856 Brighton AVD 259-D-001

February 4, 2004 BWS #00129.05

**Site Plan Modifications**

RE: Multi-Purpose Room Addition to the Breakwater School

Enclosure: SK-14, revised site plan dated 11.03.03

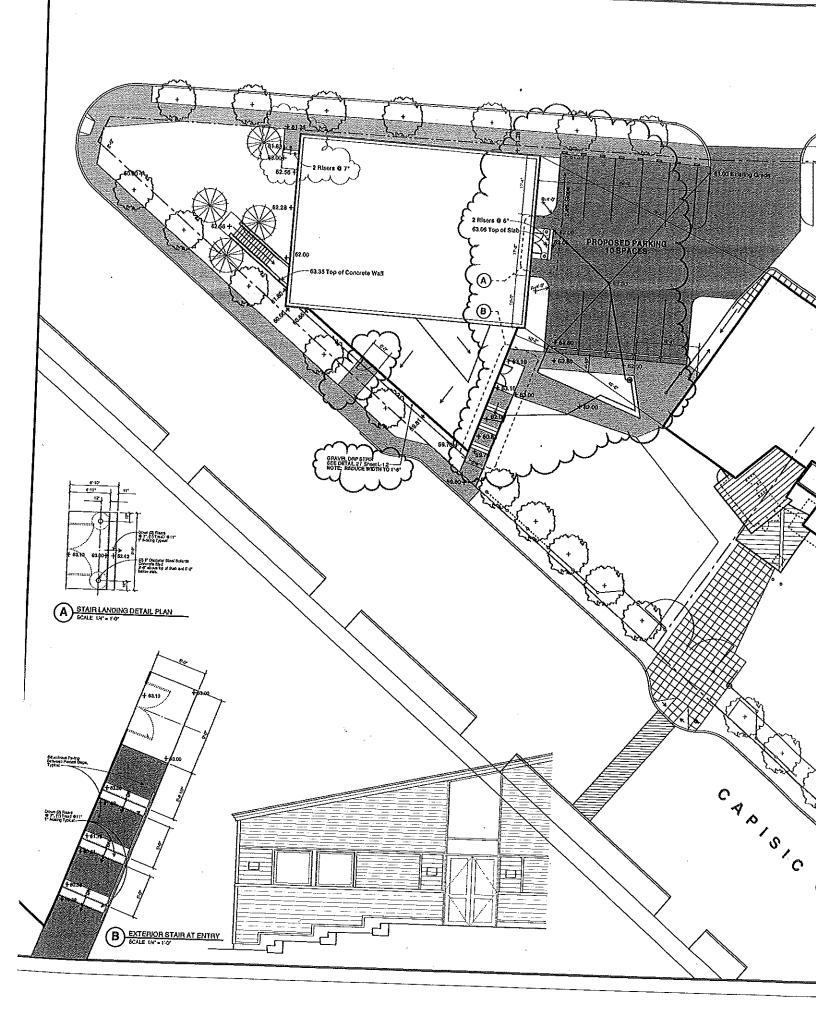
Due to final positioning of the building footprint, two parking spaces were lost.

The basic relationship and configuration of the parking did not change, however the parking count changed from 35 spaces to 33 spaces.

The parking requirement for an educational use specifies (1) space per room of instruction. With the completion of the Multi-Purpose Building there will be (17) "rooms of

instruction." The revised site plan exceeds the parking space requirement by (16) spaces.

I am in receipt of the site plan modifications from Austin Smith. These revisions are not in violation of zoning requirements, including parking. Although two parking spaces were lost, the parking requirements of the City states that there must be one parking space for each room on instruction. It is stated that there are 17 rooms of instruction. The current plans show 33 spaces provided. They are in compliance.
